# OOC SUBPART H FORUM OUTPUT DOCUMENT

Issue Date May 12, 2017

## Subpart H Clarification Questions

# Subpart H Forum - BSEE Q and A

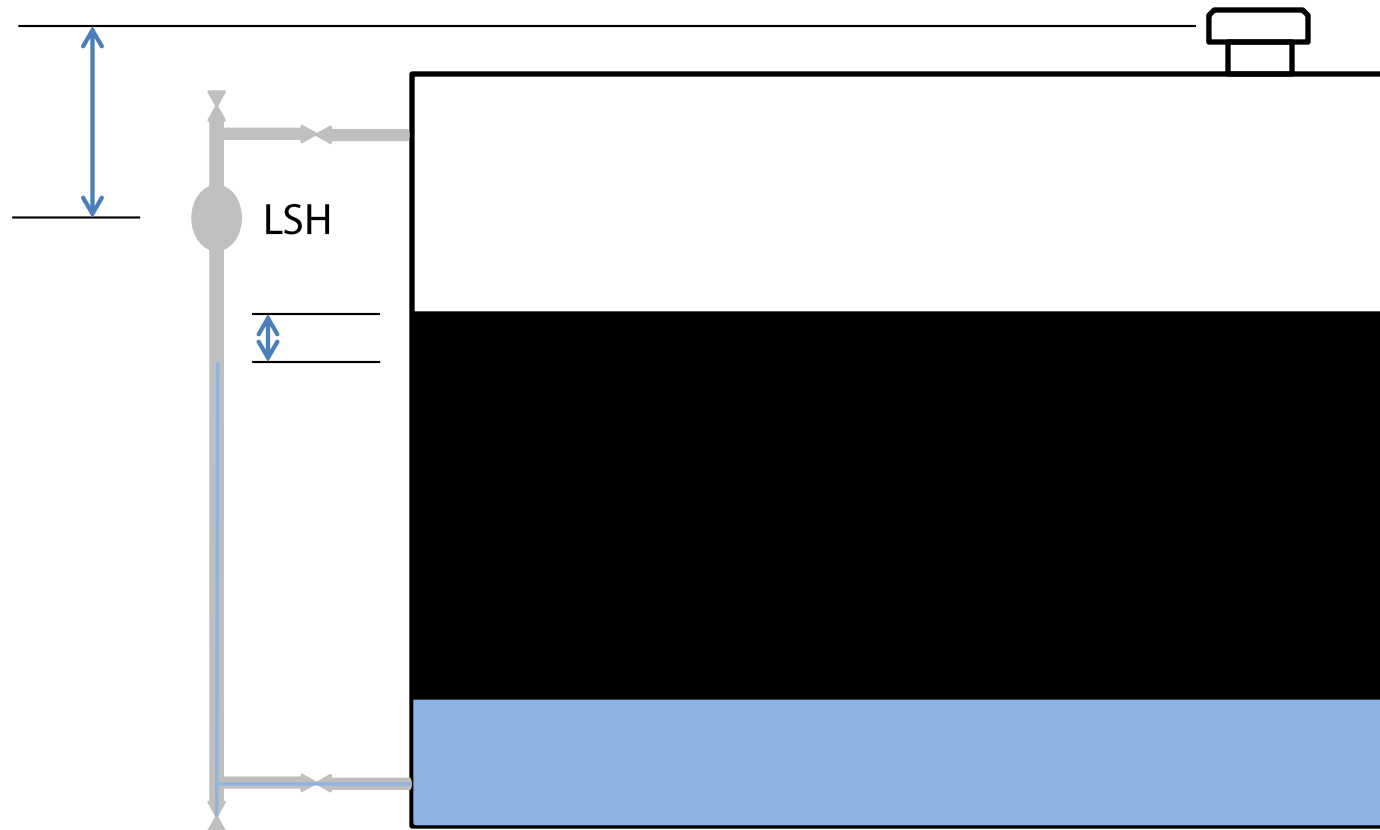
§ 250.872(b) You must ensure that all atmospheric vessels are designed and maintained to ensure the proper working conditions for LSH sensors. The LSH sensor bridle must be designed to prevent different density fluids from impacting sensor functionality. For atmospheric vessels that have oil buckets, the LSH sensor must be installed to sense the level in the oil bucket.

**The LSH sensor must be installed to sense the level in the oil bucket.**

**The level sensor must be installed in the oil bucket.**

**The level sensor may be installed in the oil bucket.**

## Atmospheric Vessels – No Oil Bucket

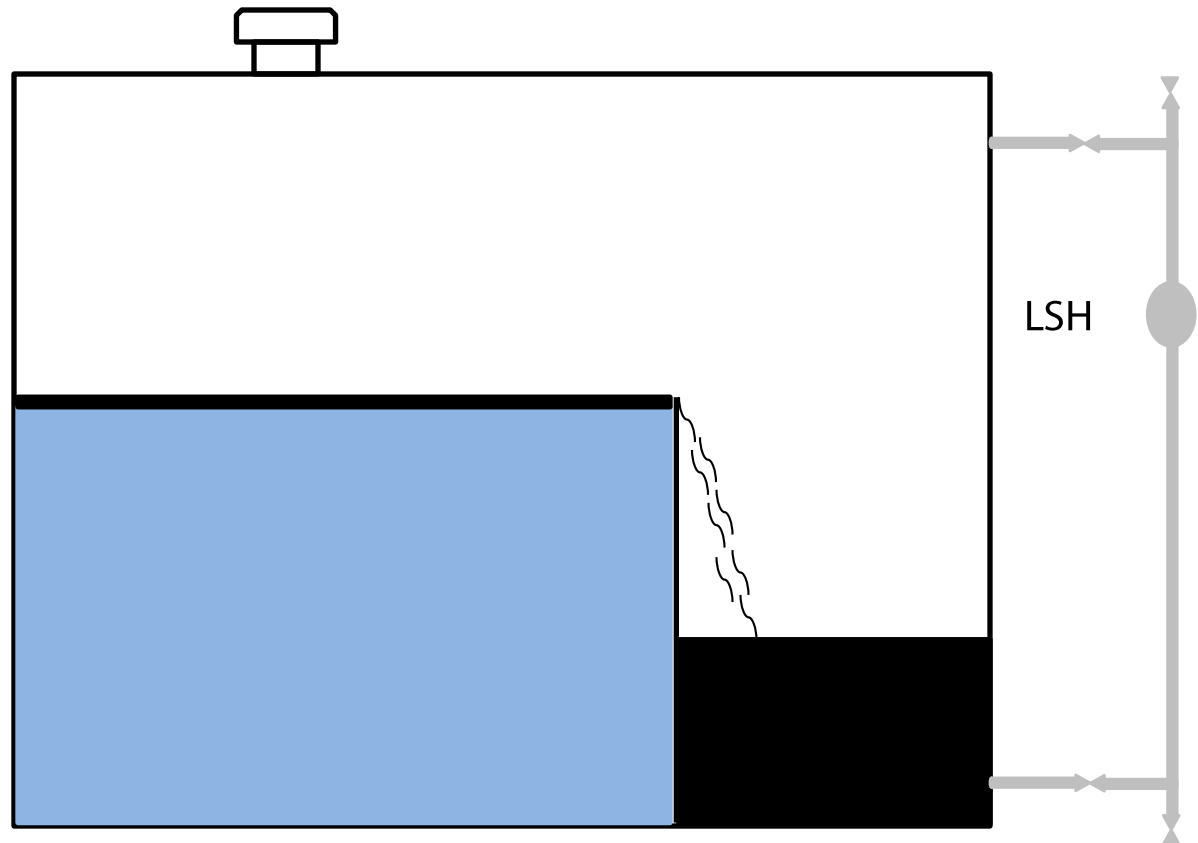
Worse Case Scenario: Vessel is filled with oil and bridle is filled with water

Overflow more likely in tanks that have the upper bridle enter the top of the tank. Oil is not capable of filling the bridle from the top.

## Atmospheric Vessels – With Oil Bucket

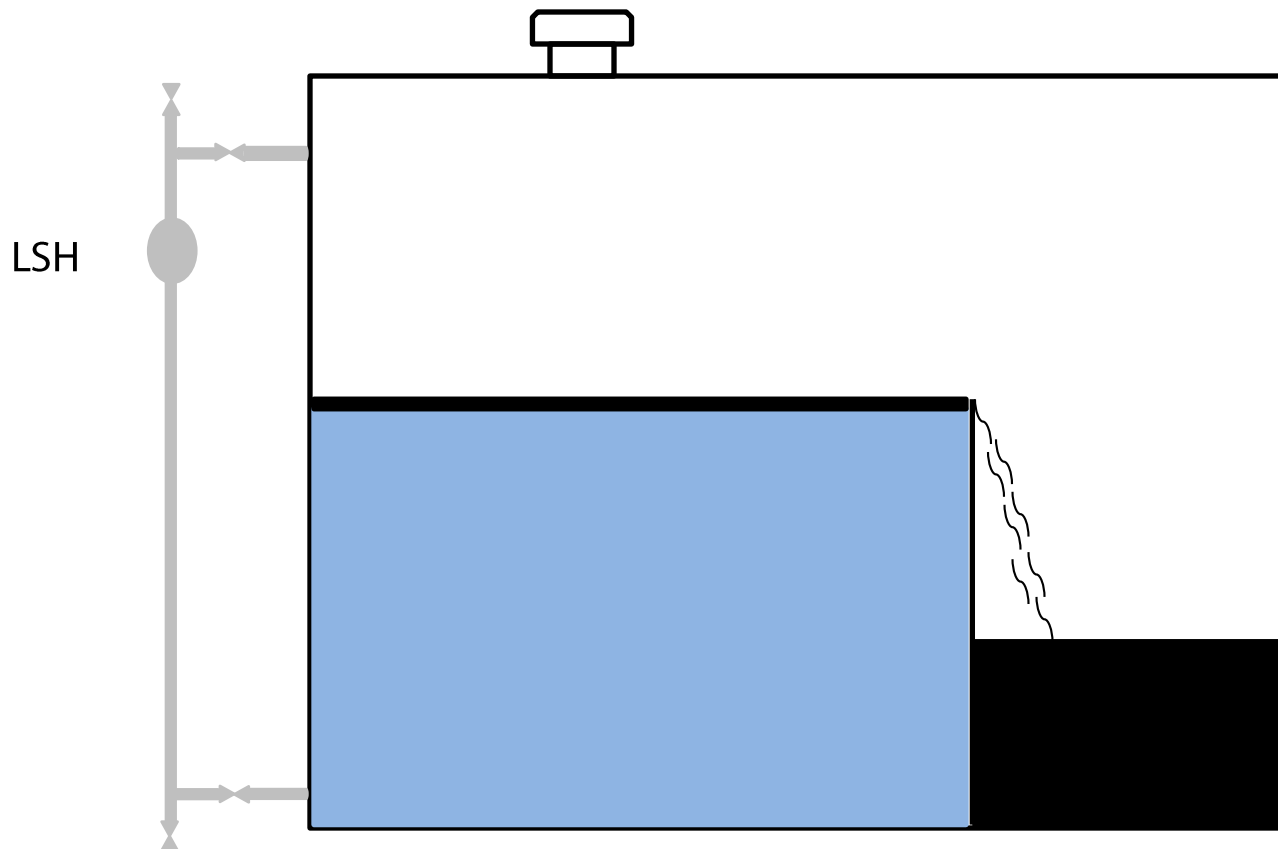
Bridle not installed in oil bucket

More likely to experience Density Difference issues.
